Subject: Handouts from the 7/20 monthly FAQ meeting
Creation Date 7/21/2006 9:27:51 AM
From: Charles Moulton

NFPA 805 Frequently Asked
Questions Program
Public Meeting
July 20, 2006

NATIONAL FIRE PROTECTION ASSOCIATION STANDARD 805 FREQUENTLY ASKED QUESTIONS PROGRAM

Figure B-1 – Process for Determining if an Active Fire Protection Feature is Required for NFA 805 Chapter 4 Compliance

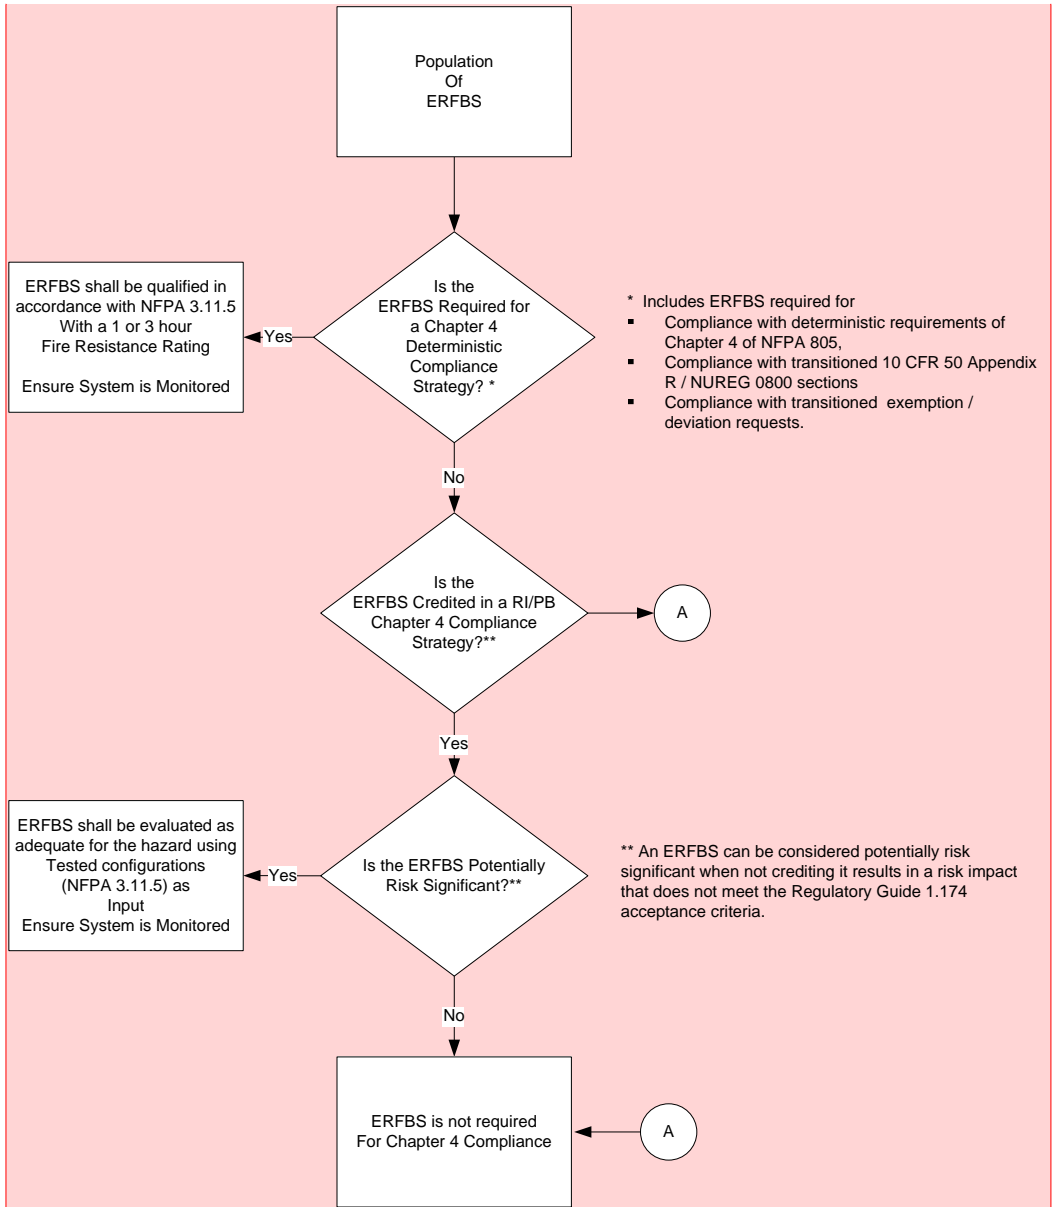
Comment [RFR6]: Acceptance criteria must be included in the licensee's fire protection license condition and must be in accordance with RG 1.205, not RG 1.174 (unless alternative criteria are submitted and approved by the NRC).

Figure B-2 – Process for Determining if an ERFBS is Required for NFPA 805 Chapter 4 Compliance

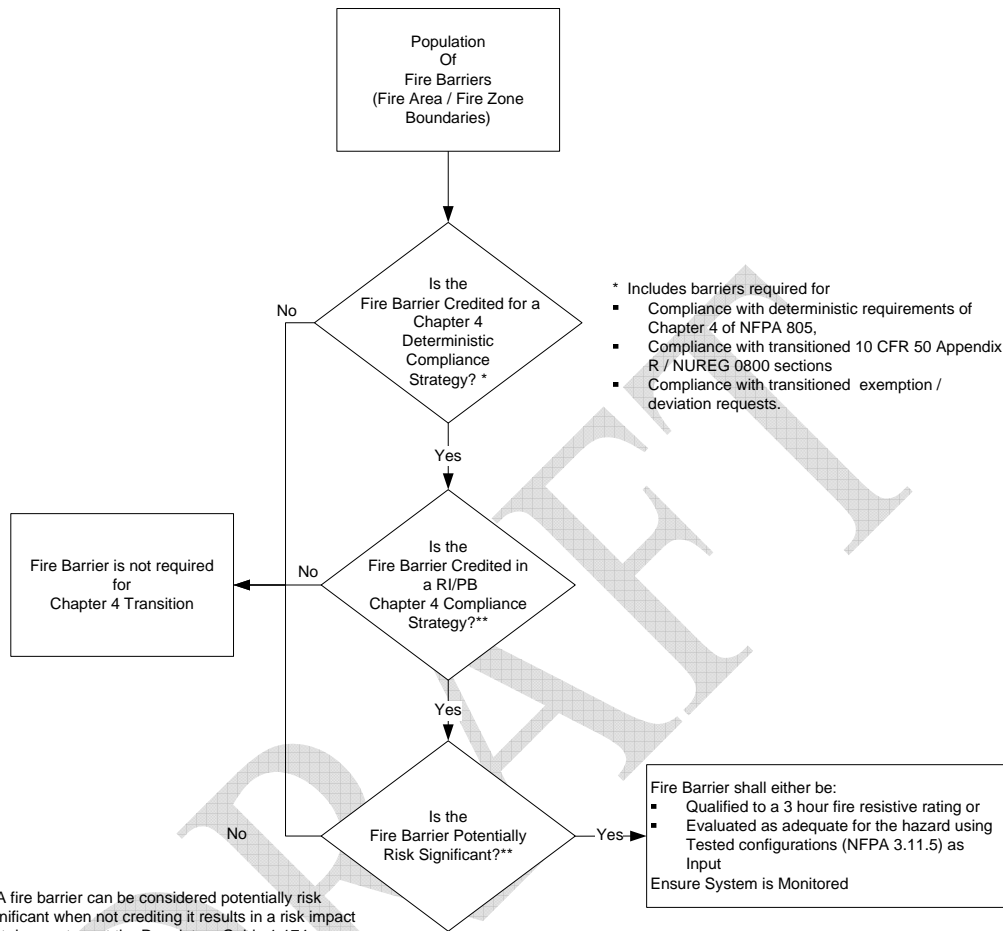
Comment [RFR7]: See comment above on risk acceptance criteria.
